New functions and addendum

- This document contains descriptions of how to set the new functions and their restrictions. It is recommended to read them while referring to the Operating Instructions provided with this product together.
- Depending on the model used, the screens shown in the explanations may differ to the actual camera screens.
- The model number is abbreviated in some descriptions in this manual.
- This document is for the following models.
WV-X6533LN, WV-S6532LN

Due to software upgrade, the following functions have been added and changed to this product.

8. Add ONVIF® settings in Network

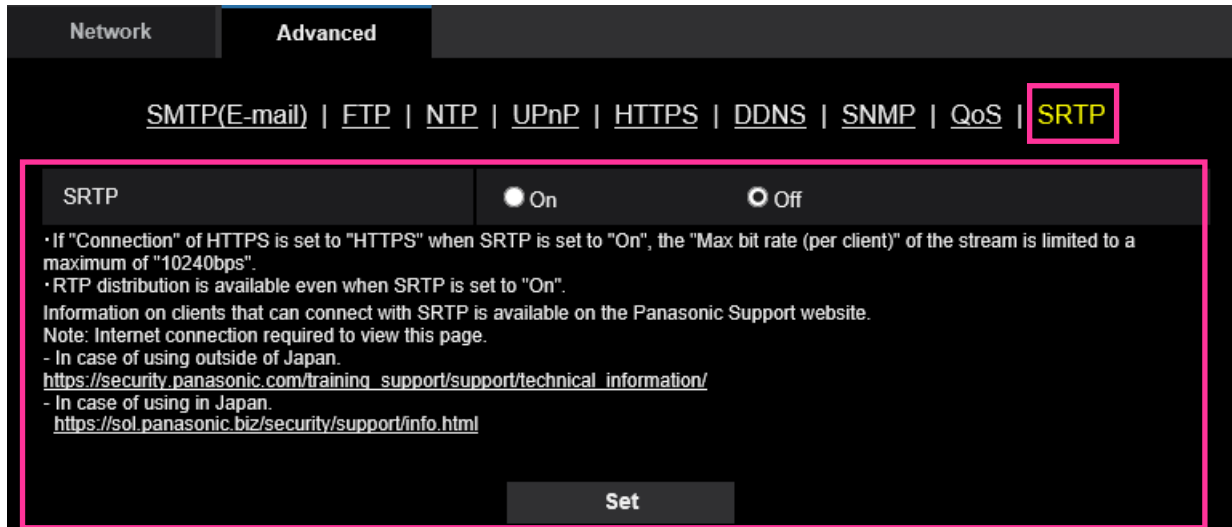
Add ONVIF® settings in the network settings.

[ONVIF®]

Set the ONVIF to On/Off.

On: Enables the access from the ONVIF camera.

Off: Disables the access from the ONVIF camera

Default: On
